October 31, 1984

Crystal River Unit 3 (CR-3)

Responses to NRC Letter Concerning Inservice Testing of Pump and Valves

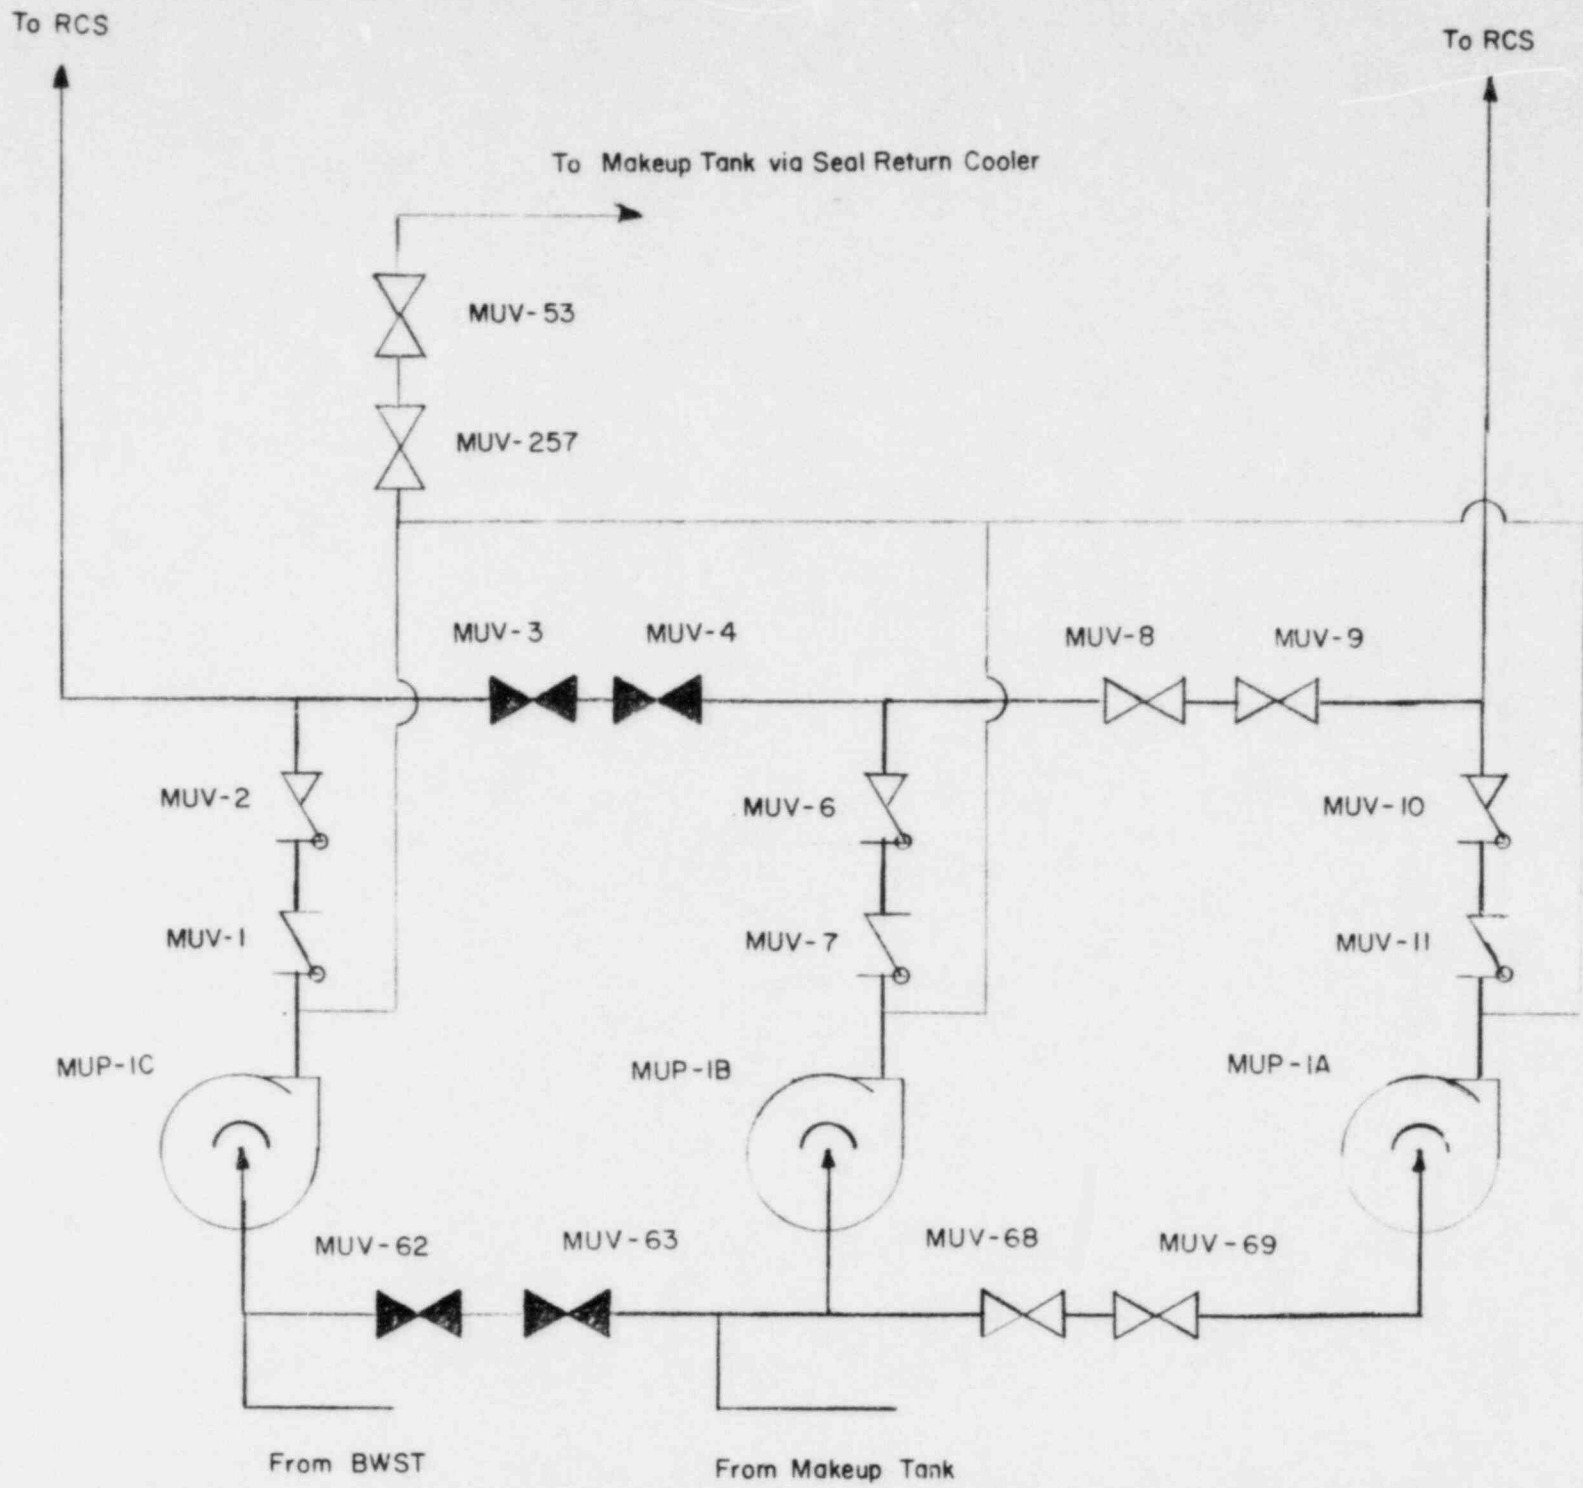
- Q5. The licensee has requested specific relief from the exercising requirements of Section XI for valve DHV-91, decay heat removal system to pressurizer spray isolation, and has proposed to stroke and stroke time at cold shutdown. The licensee states that stroking this valve during normal plant operation would be potentially compromising to the decay heat system by stroking a valve connecting a high pressure system to a low pressure system. The licensee states the valve has no safety function. We disagree with the licensee and our position is that this valve should be stroked quarterly. We do not agree that the valve has no safety function.

- R5. A change to the quarterly valve stroking procedure has been initiated. This change will add valve DHV-91 to this procedure.
- Q6. The licensee has requested specific relief from the exercising requirements of Section XI for valves MUV-53 and 257, makeup pump minimum flow recirculation valves, and has proposed to exercise these valves at cold shutdown. The licensee states that stroking of these valves during normal plant operation would interrupt minimum recirculation flow on the running makeup pump. Should the valve fail in the closed position, damage would result to the makeup (high pressure injection) pump. We do not agree with the licensee's basis and, therefore, conclude that relief should not be granted. The licensee has stated that pump damage could result if the valve fails closed on the running pump. However, we have concluded that operation of the pumps could be shifted and testing conducted per Section XI.

- R6. The minimum flow path, from the makeup pumps to the makeup tank is through series valves MUV-53 and MUV-257. Closure of either valve would isolate the common header for all three makeup pumps to the minimum recirculation flow path. Isolation of this flow path would result in pump damage. A simplified sketch has been provided for clarity. Florida Power Corporation, therefore, requests that the relief be granted.

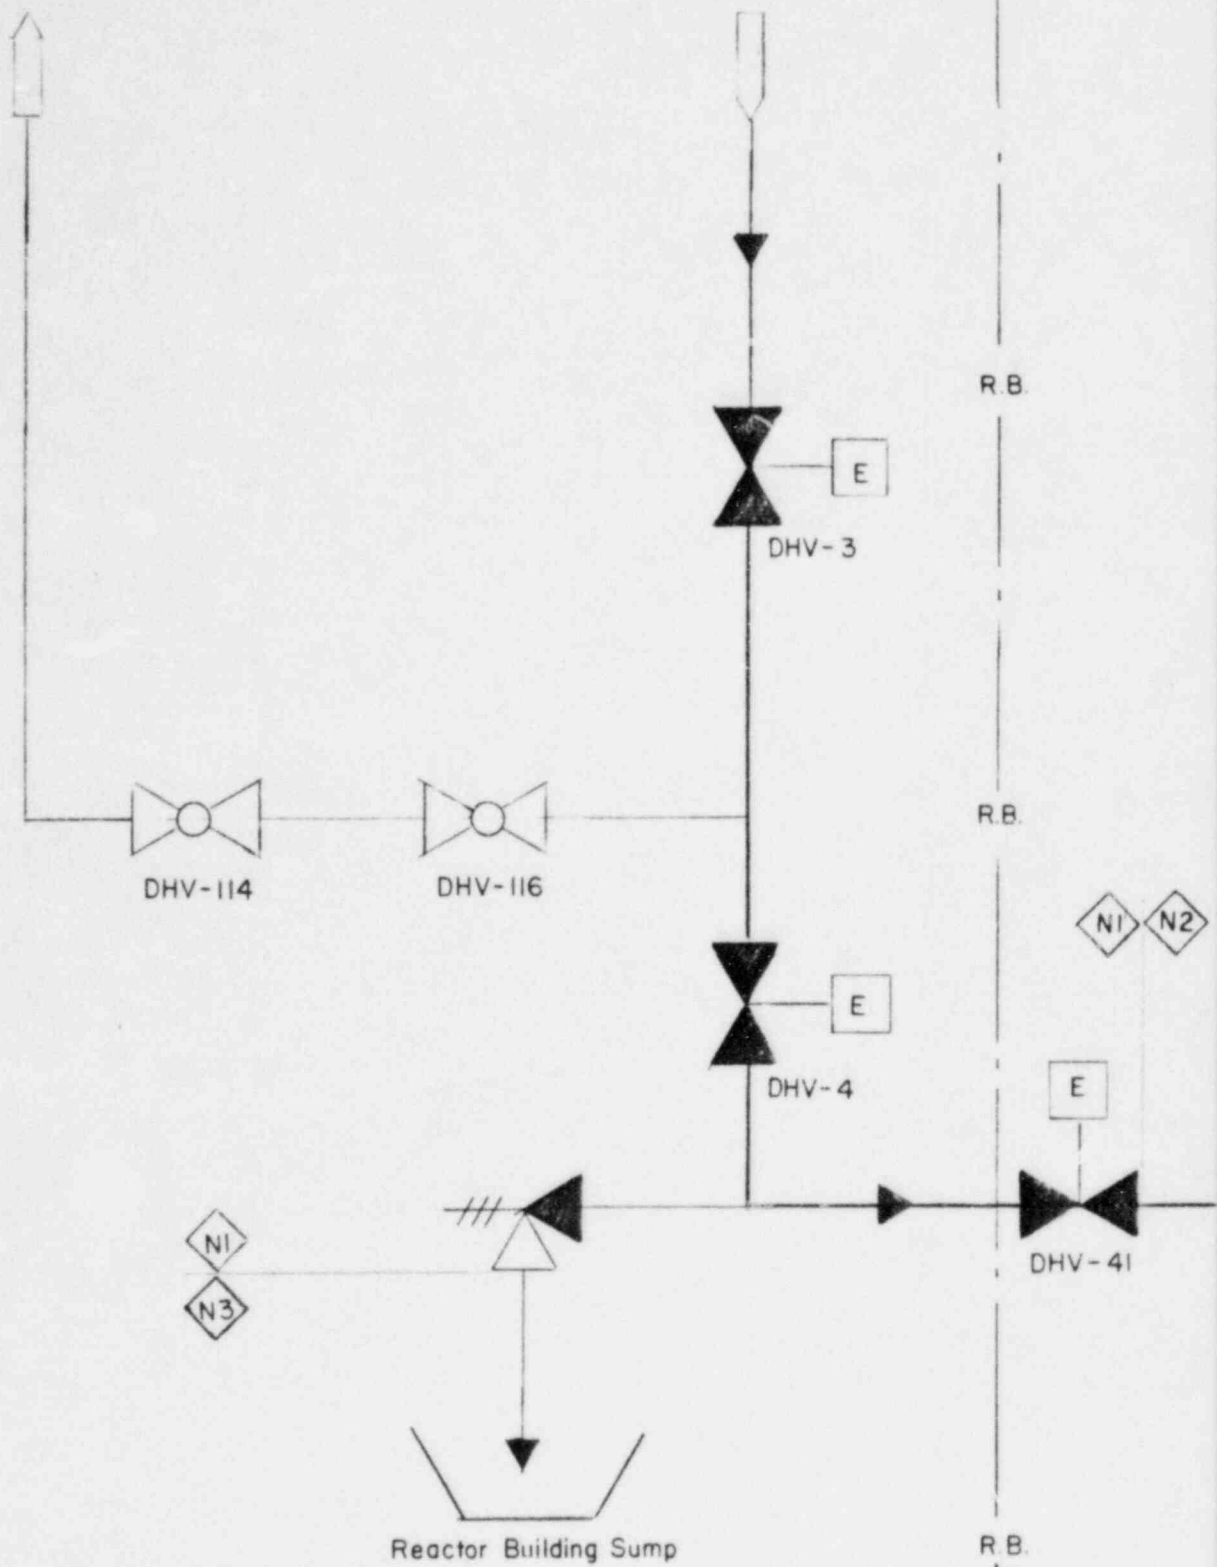
- Q16. The licensee has requested relief from the leak rate testing requirements for the following pressure isolation valves. It is the licensee's intention to use installed instrumentation to monitor valve leak tight integrity. However, the proposed method does not provide adequate assurance that the leak tight integrity of each valve is verified individually.

Valves DHV-3 and DHV-4 have an engineered system installed such that seat leakage in the closed position is inconsequential for the fulfillment of their function. Seat leakage of valve DHV-3 can flow into Class 1 piping. The only paths available for the leakage from this piping are through valve DHV-116 to the higher pressure reactor vessel or through valve DHV-4. Any seat leakage of DHV-4 will flow into the Reactor Building dump. Seat leakage of the valves will not degrade the ability of the valves to perform their function. A figure depicting these possible leakage paths is attached. Therefore, they are not category "A" valves.

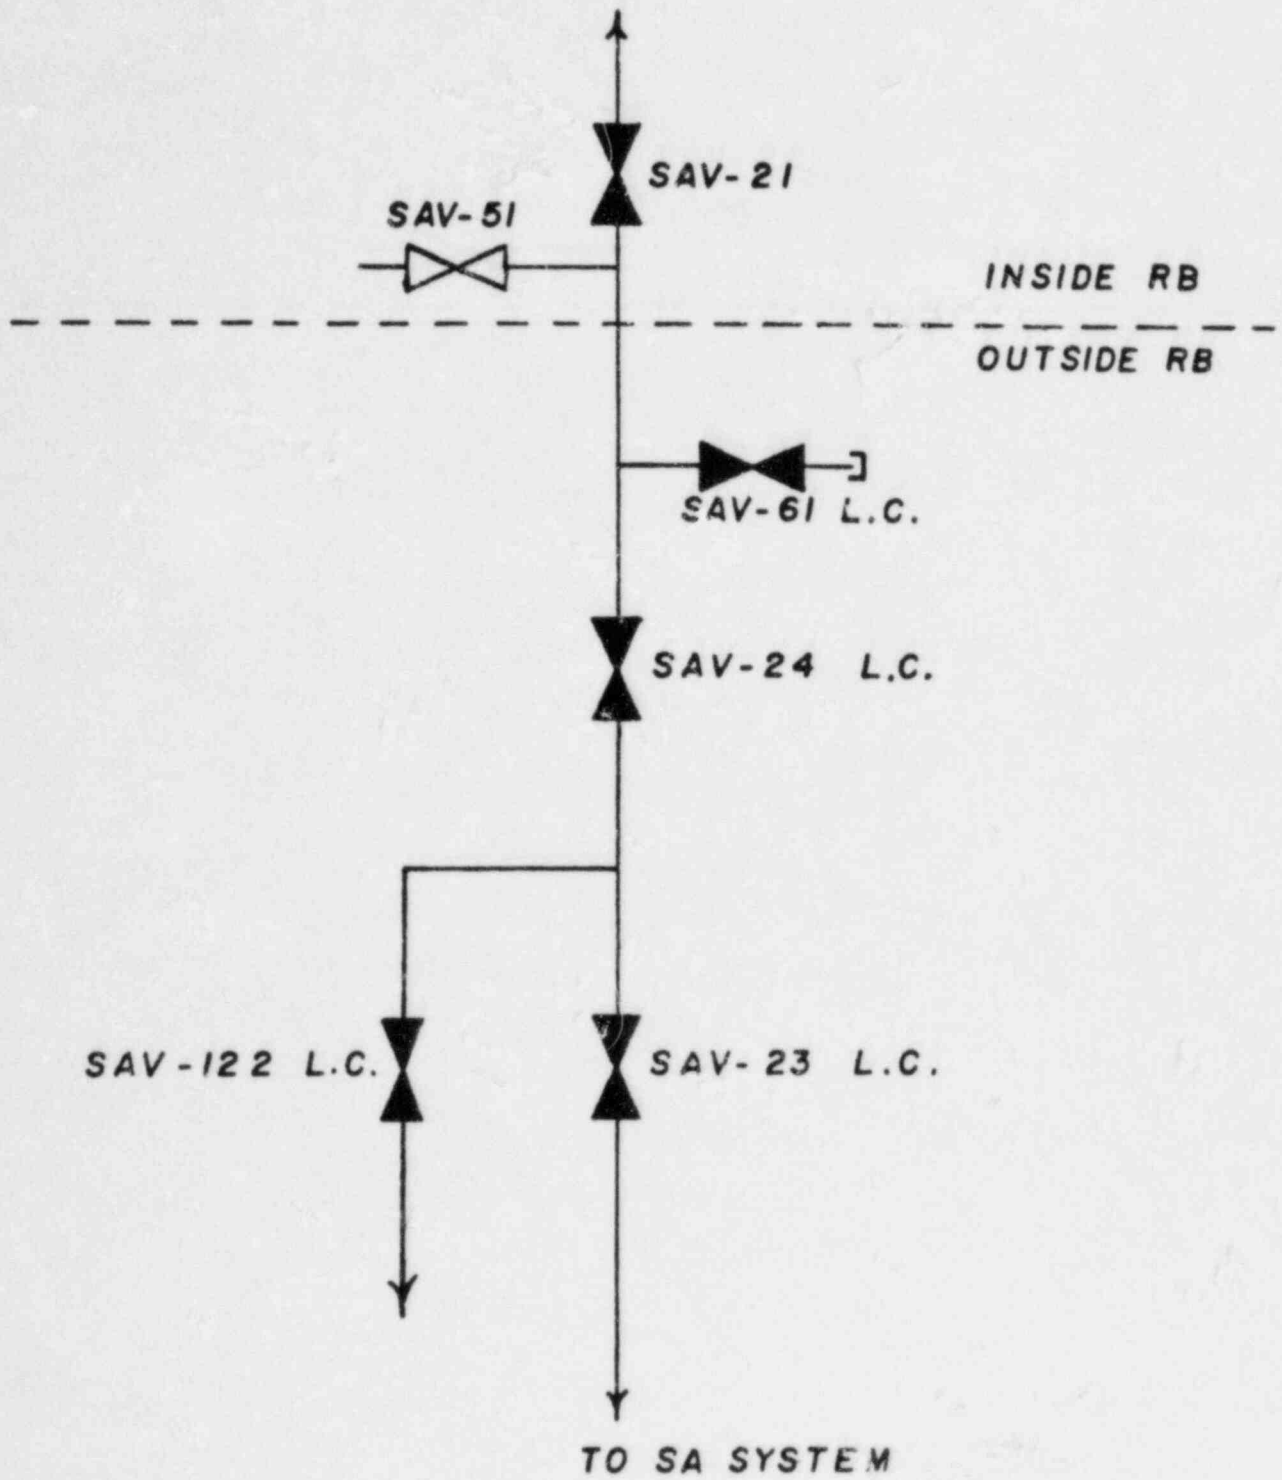
- Q20. In the working meeting the licensee agreed to change SAV-23 from Category E to Category A/E (P-2); this change was not made in the resubmittal program. Our position is that the ISI program should be revised to reflect the A/E categorization of valve SAV-23.

- R20. The NRC position is based on the temporary Post-Accident Sampling System (PASS) configuration that was employed at CR-3 until the permanent system could be installed. The installation of the permanent system has been completed, therefore, the original definition of valve SAV-23 in the program is correct. A figure showing the permanent configuration is attached. No changes to the program are needed.
